SUBJECT: Indian Point 3 Nuclear Power Plant
Docket No. 50-286
Proposed Improved Technical Specifications
Reply to NRC Request for Additional Information

**NYPA REPLY TO NRC RAI
REGARDING REVISION 0 OF PROPOSED ITS**

Figure 3.10-1

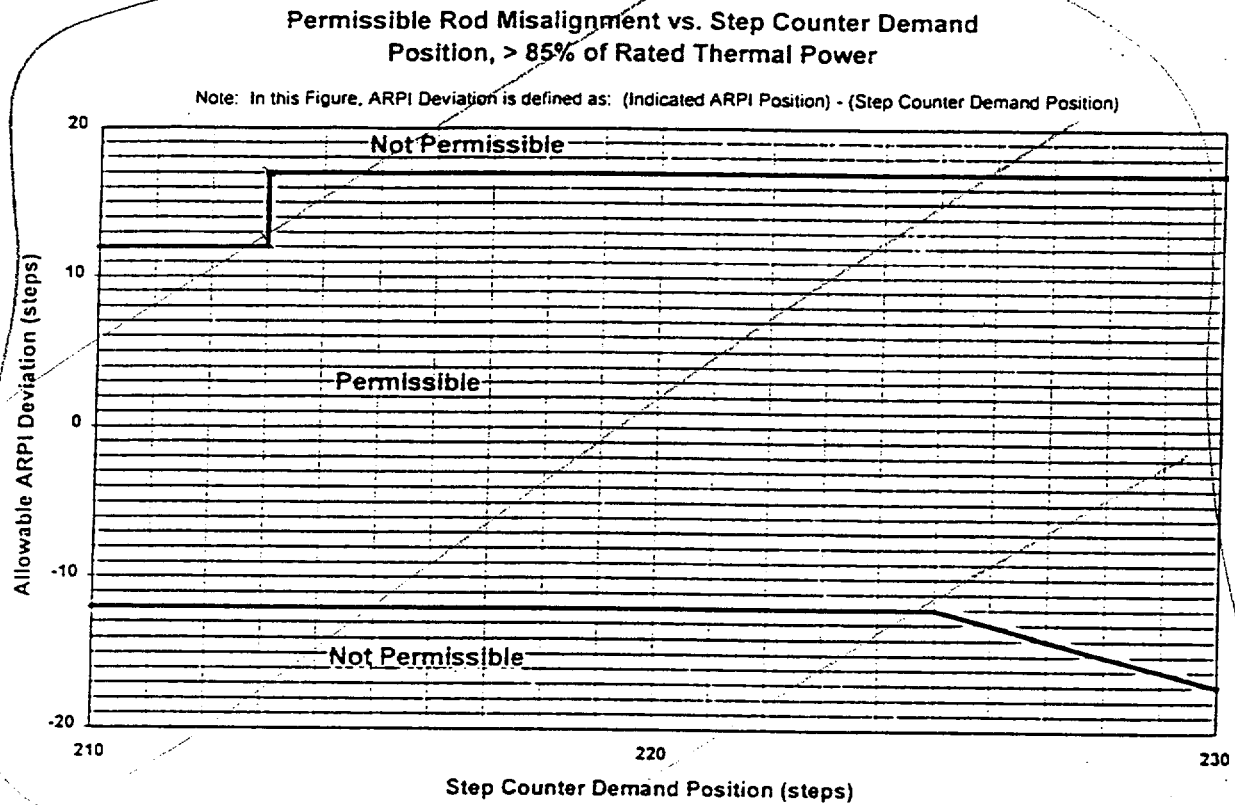
- A.15 CTS Figure 3.10-1, added by Amendment 197, establishes limits for the maximum permissible rod misalignment (indicated rod position minus group step counter demand position) when $> 85\%$ RTP. This information is presented in both Table and graphical format, either of which describes the LCO limits. ITS LCO 3.1.4, Table 3.1.4-1, maintains the same limits for permissible rod misalignment; however, the information is presented in Table format only and re-formatted for clarity. This is an administrative change with no impact on safety because there is no change to the limits for permissible rod misalignment.

Figure B 3.2.1B-1 (page 1 of 1)
 $K(Z)$ - Normalized $F_0(Z)$ as a Function of Core Height

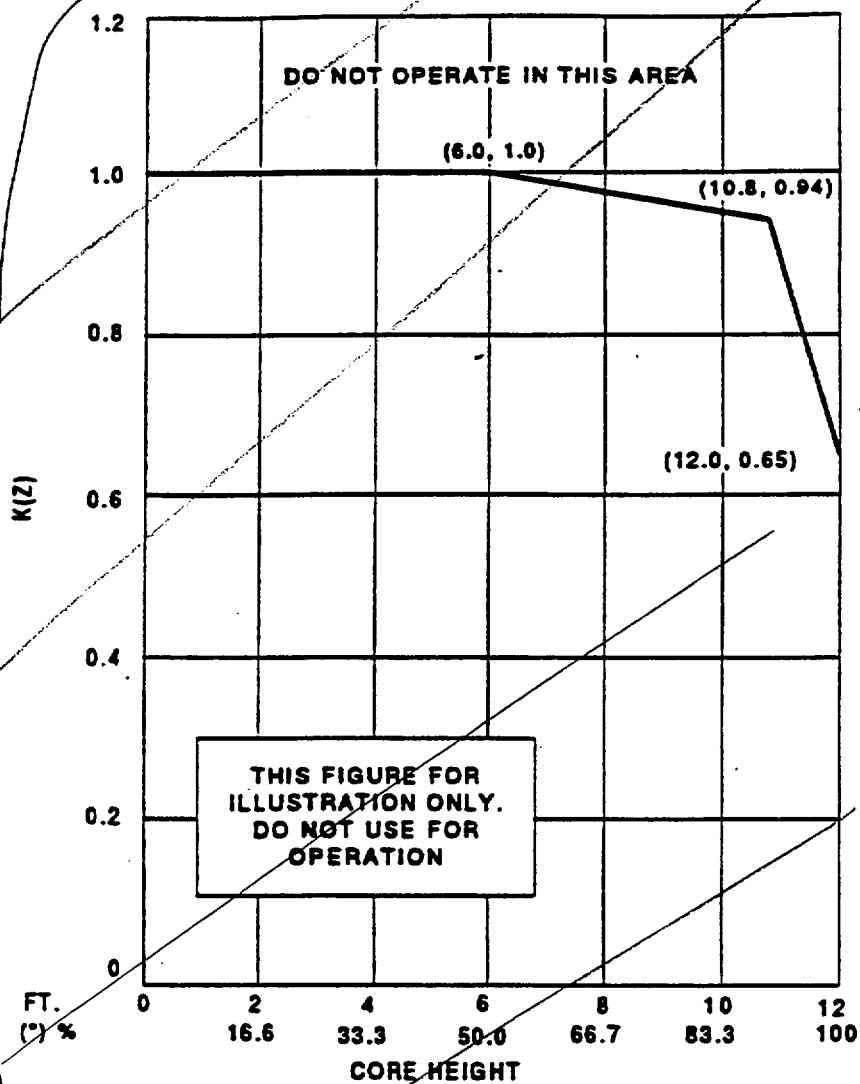
- X.1 NUREG-1431, Rev 1, Section 3.2.1, was modified to delete Figure B 3.2.1B-1 because IP3 maintains the Heat Flux Hot Channel Factor ($F_Q(Z)$) limits in the Core Operating Limits Report.
